**PARTS & SERVICE
NEWS**

REF NO.	AT99140
DATE	Sep. 16, 1999

SUBJECT: REPAIR OF CAP AT HARNESS CONNECTOR FOR ECSS (OPT.) ON WA320—WA470-3

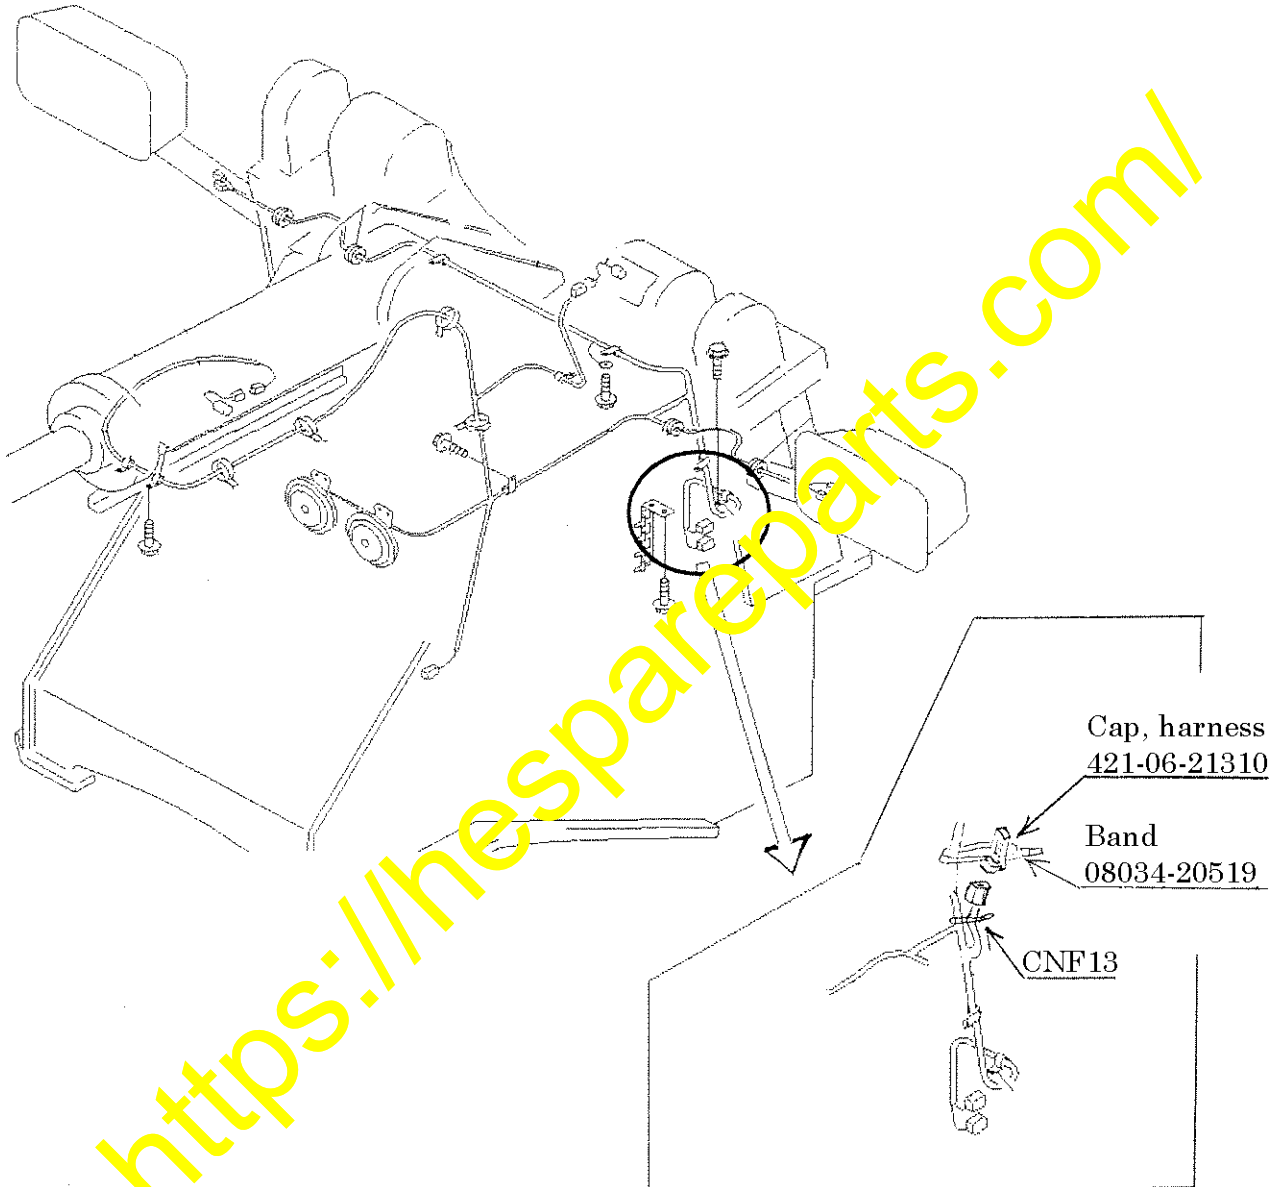
When the optional ECSS is not installed leaving the harness connector for the ECSS unconnected, a cap needs to be installed to the harness connector to prevent entry of water. However, there is a possibility that some of the above listed machines were shipped without installing such a cap and consequently, you are kindly requested to check the connector section at opportunities such as of rendering periodical services, and if the cap is found not installed, install it following the procedures outlined in this Service News.

Inspect the front harness connector (CNF13) located at L.H. inside of the front frame, to check whether the cap, harness (421-06-21310) is installed or not. (It is not necessary to check the machine with the ECSS.) If not installed, install the cap and fix it to the harness with the band.

※ If the connector CNF13 is left unused without installing the harness cap and if water enters in the harness, malfunction of bucket leveler, boom kick-out, etc. may result.
